Meeting: Conservation Commission

Date: June 12, 2024

RE: 100 Durgin Lane

Page 118 ConCom Application-what exists

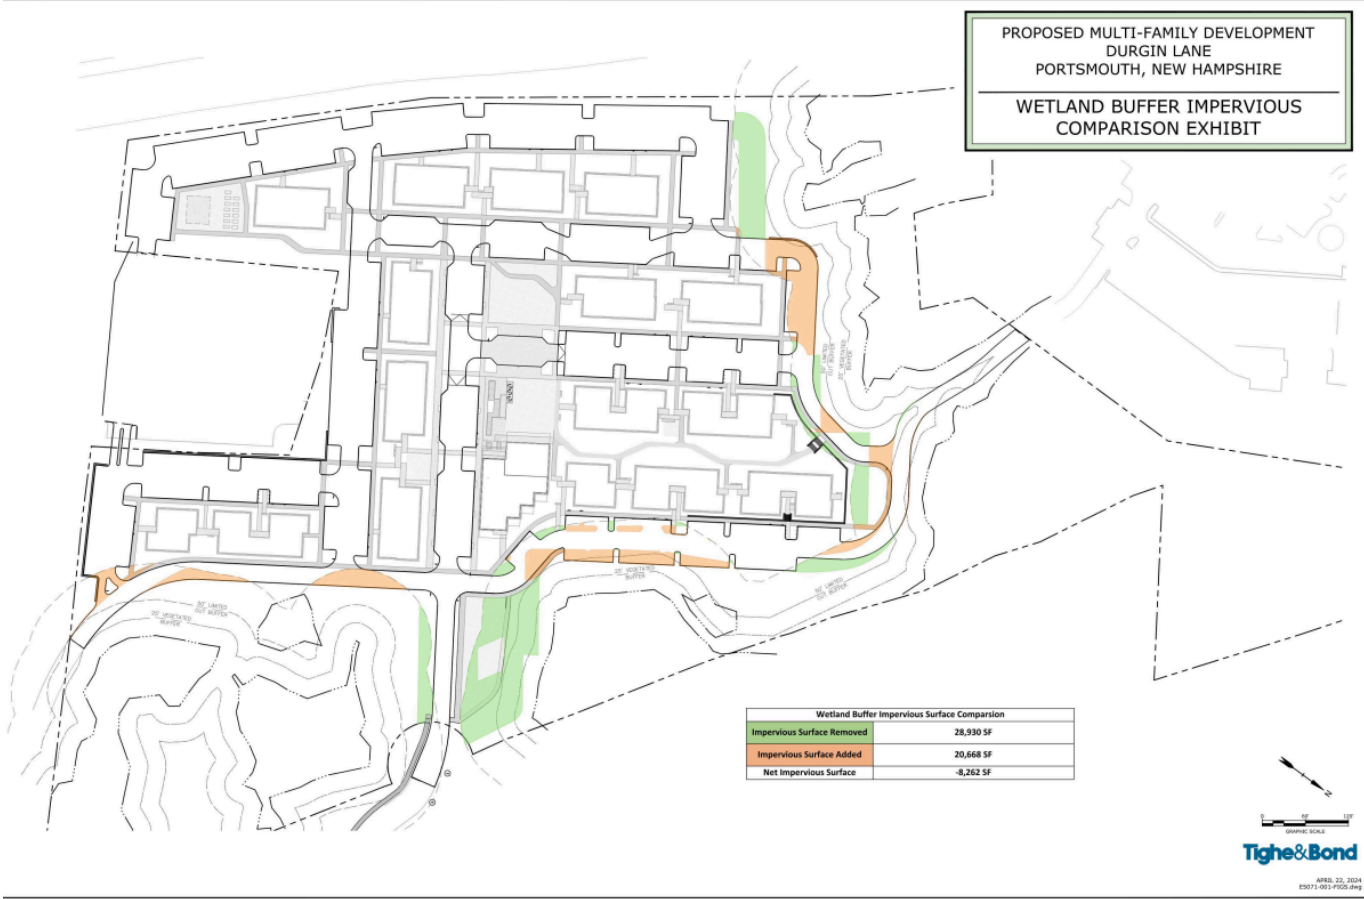
Looking at page 118 of the application, below, it is currently a large building with a very large parking lot. *An overlay graphic of what is being proposed and what currently exists could be helpful in assessing how the wetlands will be impacted.* It is true they are adding more greenspace to the lot but looking at Impervious Surface Comparison (below-page 189), one can see the cost for that greenspace involves adding parking and a road into the wetlands as well as a retaining wall.

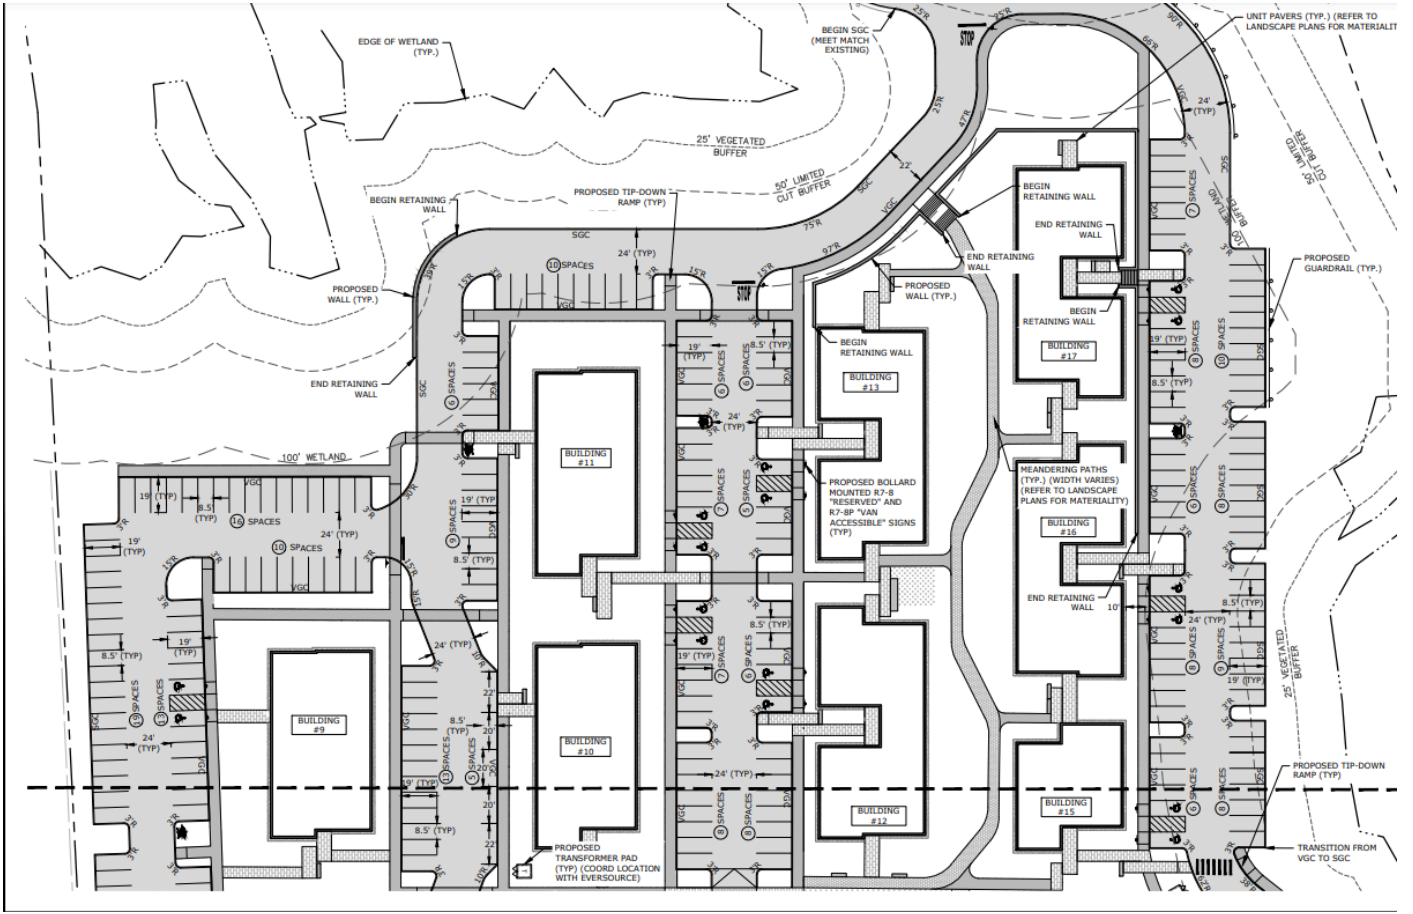
These design plans are not the least impactful. **The alternative would be to lessen the interior park sizes next to buildings #10, #11 and #12,#13 as well as move the parking area between said buildings further south. Moving these down would move 10 parking spaces and the roadway closer to the two buildings, as most complexes have and REMOVE a lot of impervious surface and add open space along the wetland buffer.** This development has a nice proportion of greenspace and this change would not be noticeable to those who eventually live there. **There are no dimensions listed** on the various plan sets making it difficult to envision how much impervious surface was removed and where. It is also difficult to assess how much greenspace will exist. In the plan sets from TAC (pages 234,235,235) the parking dimensions and building numbers are shown (last two plan sets shown)

The area next to buildings #10,#11 in the wetlands are minimally 85' (8.5' X 10 spaces) wide by 19' long parking spaces with 24' wide roadway (43 X 85) about 3655sf. The area by the parking lot is 62' long and 22' wide, about 1364 sf. The actual length of the roadway was difficult to ascertain but it is 22' wide. **Guessing over 7000 sf of impervious surface could be moved out of the wetland buffer with this change.**

EXISTING WETLAND BUFFER IMPERVIOUS SURFACE
SCALE 1" = 100'

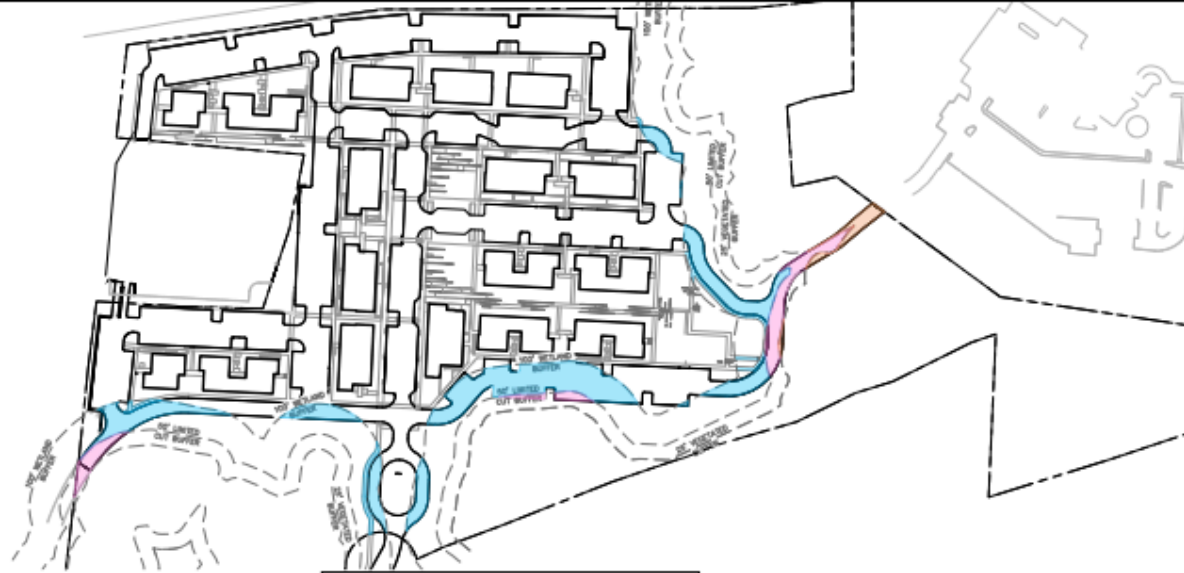
Here are the direct comparisons of the June proposal and then revised July proposal, as well as the plan set which shows the buildings, greenspace and the wetland buffer lines. The green space to the South could be made smaller to avoid the wetlands to the North. The June to July changes show an attempt to do so.

The road next to the newly proposed rain garden (park) could be revised to follow the 100' buffer line on the south side OR could be designed like an "L", both could keep the road out of the 100' wetland buffer and the proposed rain garden (park).

The corner of the road which rounds into the 100' wetland buffer, between the two buildings at the top, could be moved by making the playground slightly smaller.
